# SERVICE LETTER

No. 667A

Piper Aircraft Corporation

Stabilator Attachment Bolts

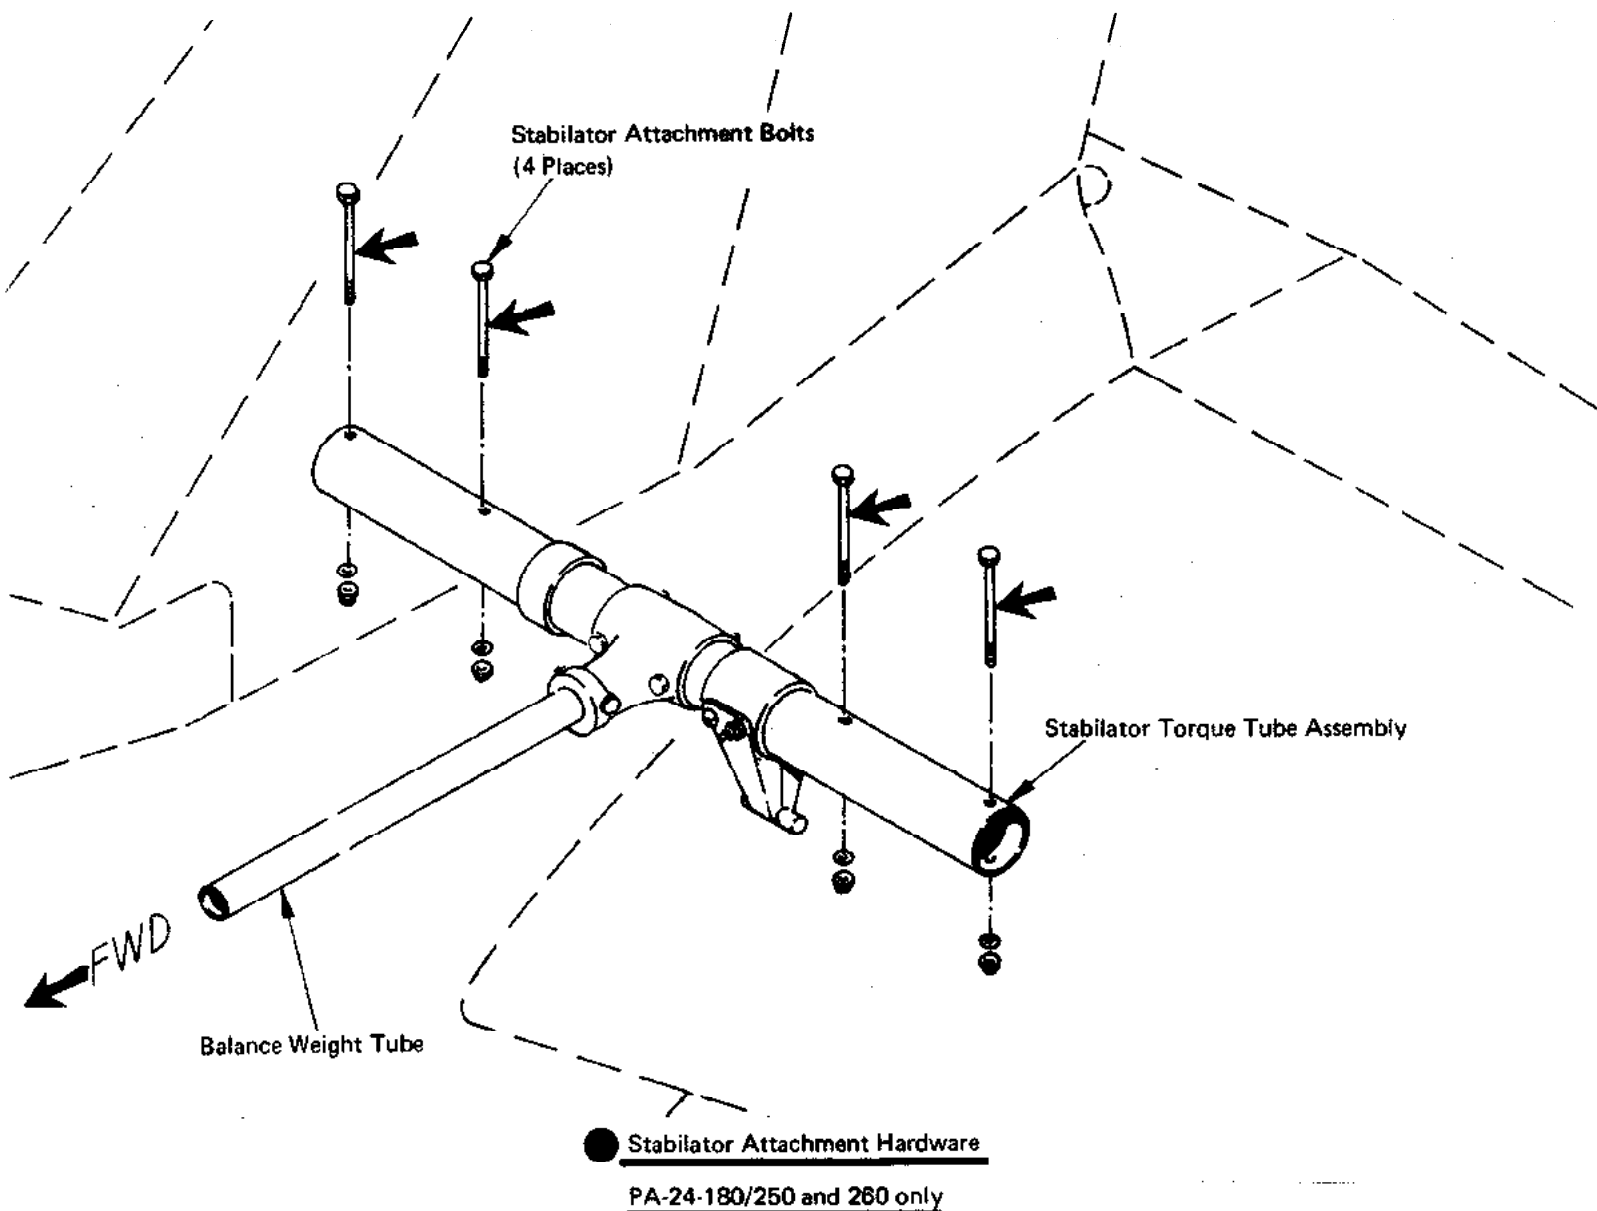
1. Revised Compliance Time, below.
2. Added alternate replacement hardware material, refer to attached sketch/instruction sheet for new replacement hardware identification data.

Remove existing stabilator attachment bolts, washers and nuts, indicated on sketch, and install new bolts and attaching hardware.  
**CAUTION:** Remove and replace one bolt at a time. Refer to sketch for correct replacement hardware identification and proper assembly of bolts, washers and nuts.

2. Correct torque value for bolts is as follows:

- a. PA-24-180/250 and 260 - torque to 30-40 inch lbs.
- b. PA-23-235/250/250 (Six Place) and PA-24-400 - torque to 60-85 inch lbs.
- c. PA-30 - Refer to the Twin Comanche Service Manual (Section 4 - paragraph 49) which states that the nuts ("holding the stabilator to the torque tube") should "be tightened just enough to take the play out of the washers."

Bolt AN174-C32A P/N 502 329 (Corrosion Resistant) or Bolt AN174-32A P/N 402 329 (Non-Corrosion Resistant)  
 Washer AN960-416L P/N 407 585  
 Nut MS20365-428C P/N 404 888

PA-23-235/250/250 Six Place, PA-24-400 and PA-30 only

Bolt AN175-C32A P/N 502 342 (Corrosion Resistant) or Bolt AN175-32A P/N 402 342 (Non-Corrosion Resistant)  
 Washer AN960-516 P/N 407 566 (PA-23-235/250 and 250 Six Place only)  
 Washer AN960-516L P/N 407 586 (PA-24-400 and PA-30 only)  
 Nut MS20365-524C P/N 404 889
